BIDDER QUESTIONS

The following questions were received during the Pre-bid site walkthrough at Detroit Diesel, followed by responses provided to present clarification to the bidders.

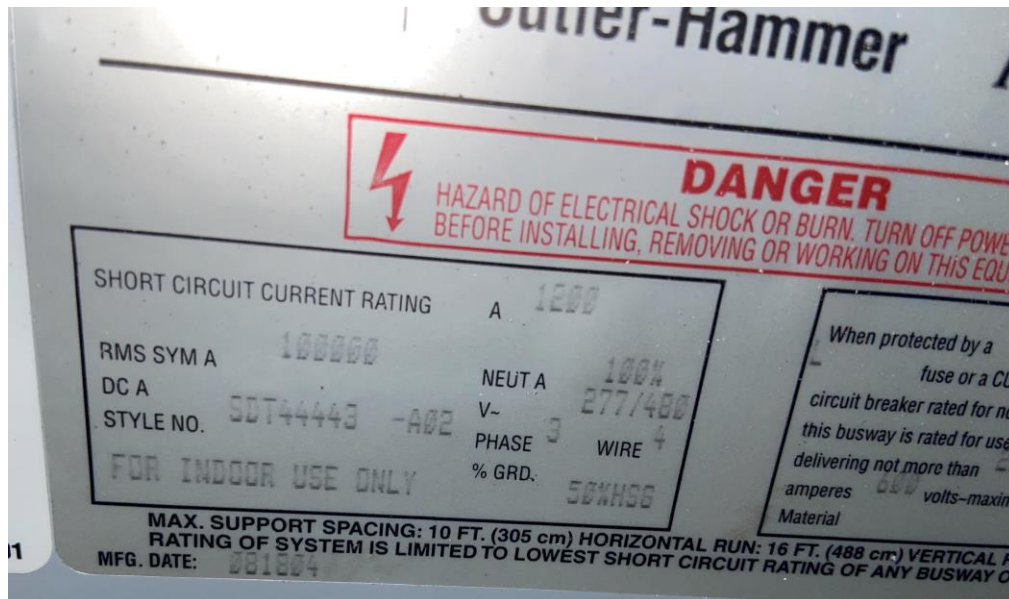
Question #9: How does the powder feed hopper / lime injection equipment tie into the ductwork. Does all the equipment come pre-mounted on a skid or are there multiple pieces of equipment that need to be installed.

Response #9: Attached is a general arrangement drawing that can hopefully help. Basically, the difference from this to what you will get is the top lid will be for manual loading where you open and fill. And we will have a stand so that you can put 5" or 6" diameter pipe underneath to draw the material in the pipe. You can reduce to 4" to go to your main exhaust duct header. The 5" or 6" TEE or elbow would be open and not connected to the feeder (null fitting so we are pulling plant air as its feeding into the pipe. Once fed in pipe reduce to 4" diameter and send to main exhaust duct. This system needs to be indoors. Each unit will require a 1/2" compressed air line for the pneumatic vibrator operation.
